E5071-001
August 28, 2024

Re: **Request for Wetlands Conditional Use Permit Review**
100 Durgin Lane – Proposed Redevelopment

The project was last presented before the Conservation Commission on August 14, 2024. The following is a response to comments made in order to address feedback received from the Commission at that meeting:

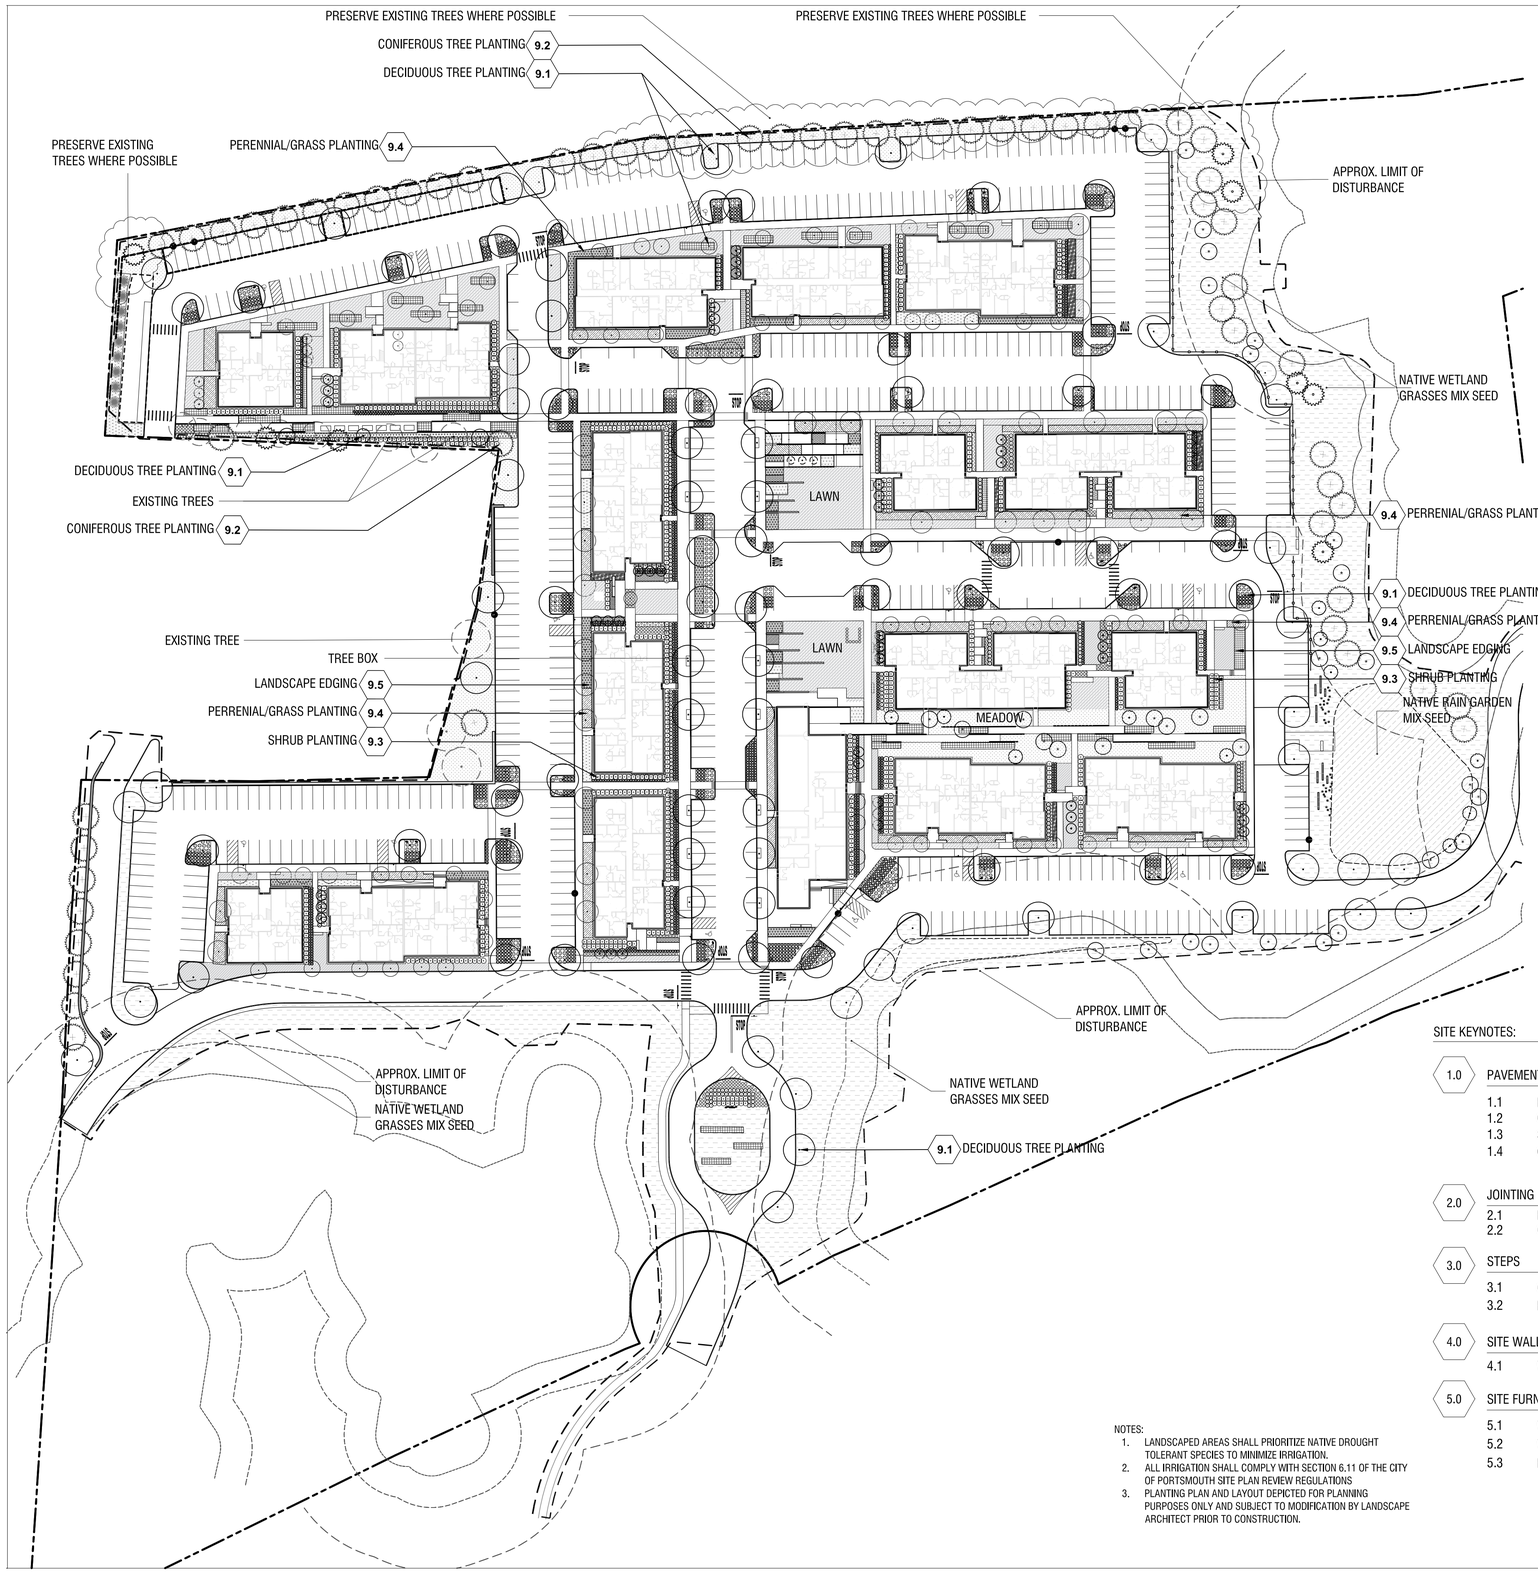
2. *Specify planting and tree sizes, types and locations.*

Response: Refer to Sheet L3-00 for full planting schedule and plan.
